The Columbia Architectural Design Review Team will meet on Tuesday, July 11, 2023 at 9:00 AM in Conference Room A on the basement level of City Hall, 700 N. Garden Street. The Planning Commission will consider the following:

ART 23-0199

The applicant is requesting façade approval for two new buildings proposed within the Beechcroft Plaza Planned Unit Development. The PUD-MU design standards are applicable. The proposed structure is a one story Commercial building (Zoning Ordinance Table 4.3.8.B, p. 216) with a Shopfront frontage (Table 4.3.7.A, p.203). The application does not indicate frontage type, but it appears to most closely match the Shopfront. The PUD-MU standards prescribe a minimum two story building height. The application depicts single story structures. Presumably the applicant will ask Planning Commission to approve a deviation from this standard as part of the revised PUD Master Plan. The applicant has provided floor plans and a site plan in addition to building elevations.

CITY OF COLUMBIA TENNESSEE ARCHITECTURAL DESIGN REVIEW STAFF REPORT

3 West Elevation
SCALE: 3/16" = 1'-0"

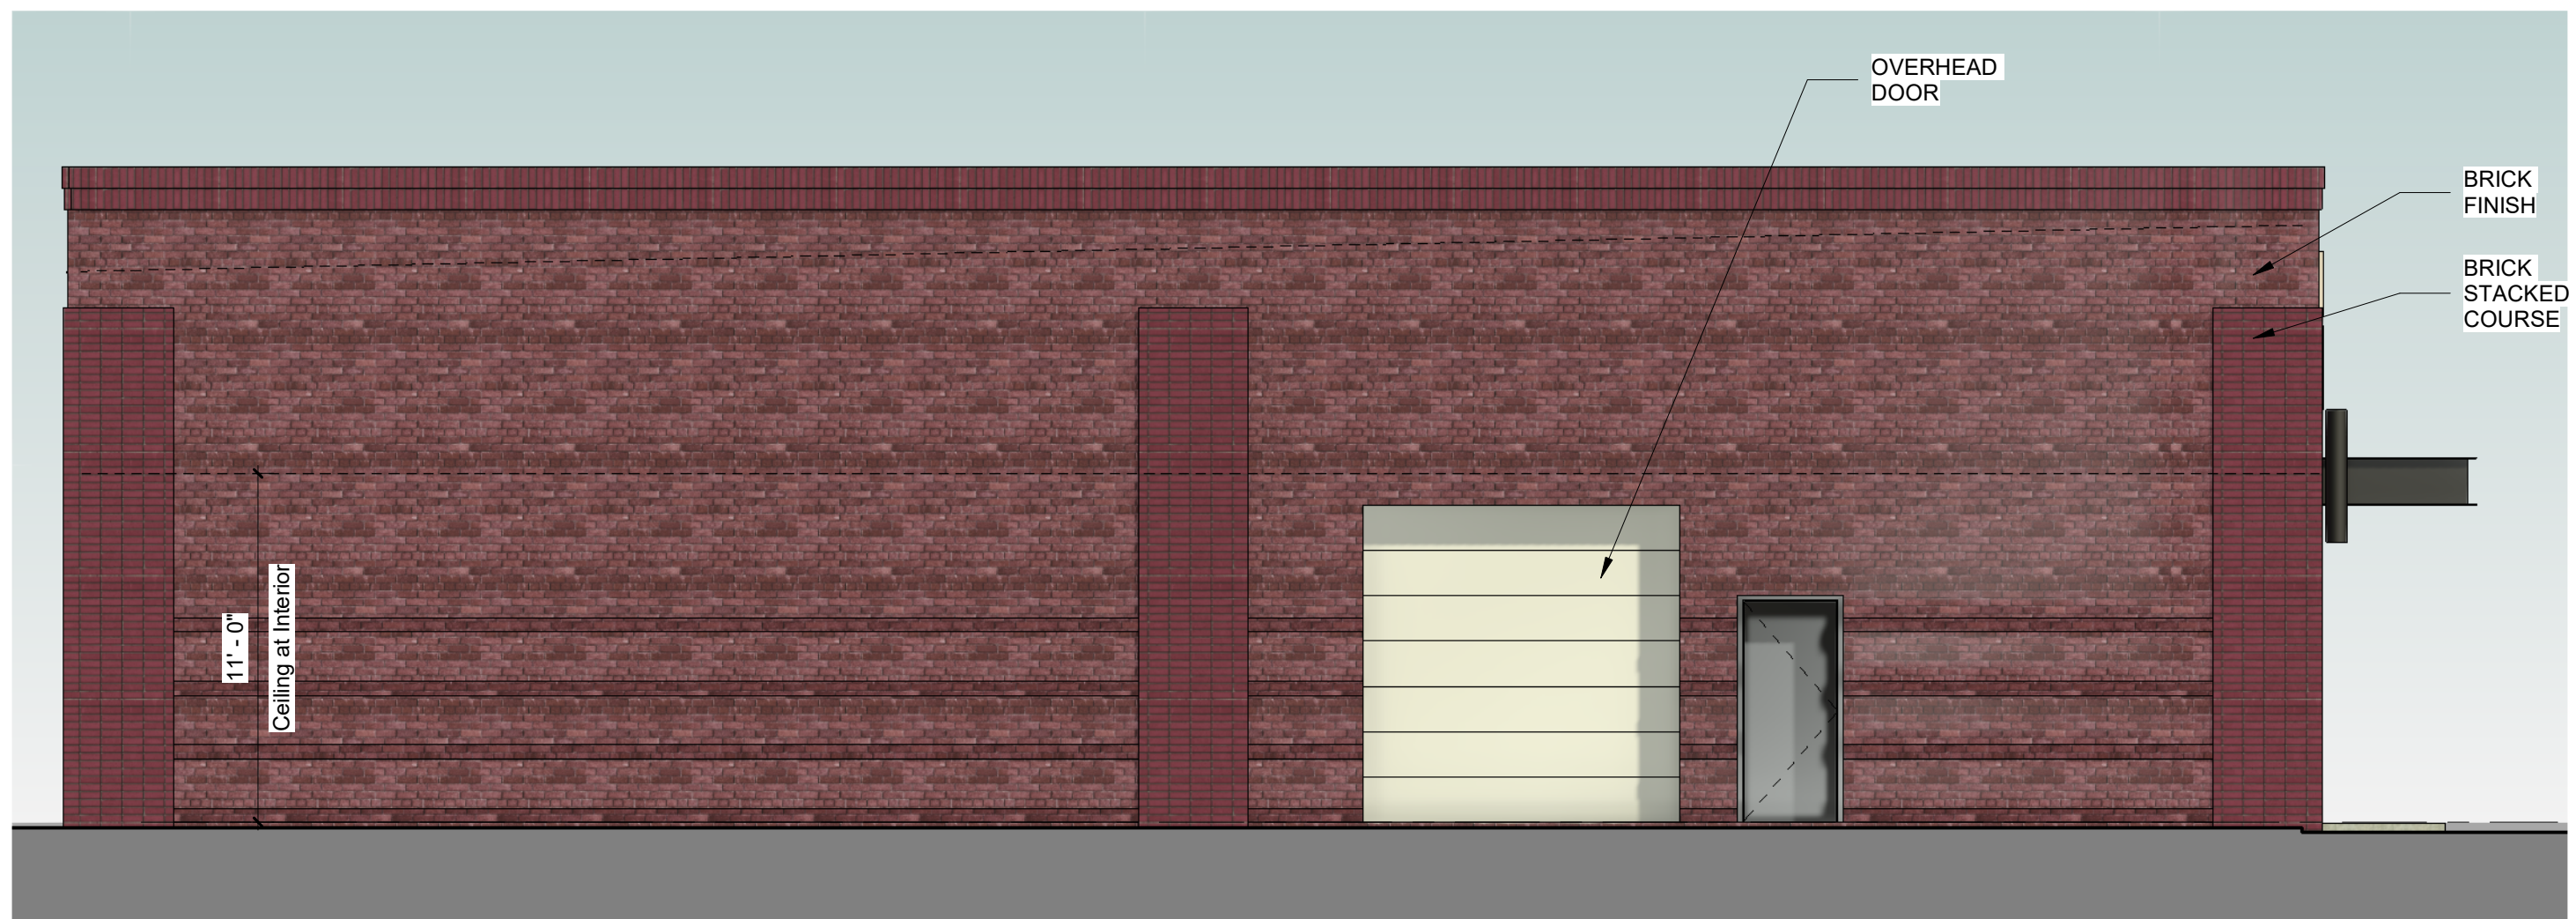
- Primary building materials on the proposed front elevations consist of brick, which is a permitted primary material for Facades in a PUD-MU.
- Rear and side elevation are metal panel siding. Primary façade materials must continue through the second layer and transitions must occur at changes in form, structure, or massing. The material changes occur beyond the corners of the structure and should be at least 20 feet beyond the façade. It is preferable for the building to completely omit the metal panel siding, especially of the side elevations.

- The Façade width is greater than 100 feet. Façade articulation is provided by partial brick pilasters.
- The Ordinance requires a ceiling height of 11 feet. The design appears to provide this ceiling height.
- The Facades of the two proposed structures are aesthetically similar but satisfy the requirement for façade variety.
- The building utilizes no more than three colors as prescribed by the ordinance.
- The proposed structures utilize a flat roof, which is permitted.
- The proposed Façade elevation does not include a knee wall. The Zoning Ordinance requires this feature is required for PUD-MU shopfronts.
- The PUD-MU standards require 70% for Shopfront frontages (20% - 60% for other frontage types). The proposed building appears to provide no more than 20% glazing.

- That the side elevations be brick rather than metal;
- The applicant confirms the finished ceiling height;
- That the glazing increase; and
- That the applicant add a knee wall to the façade.
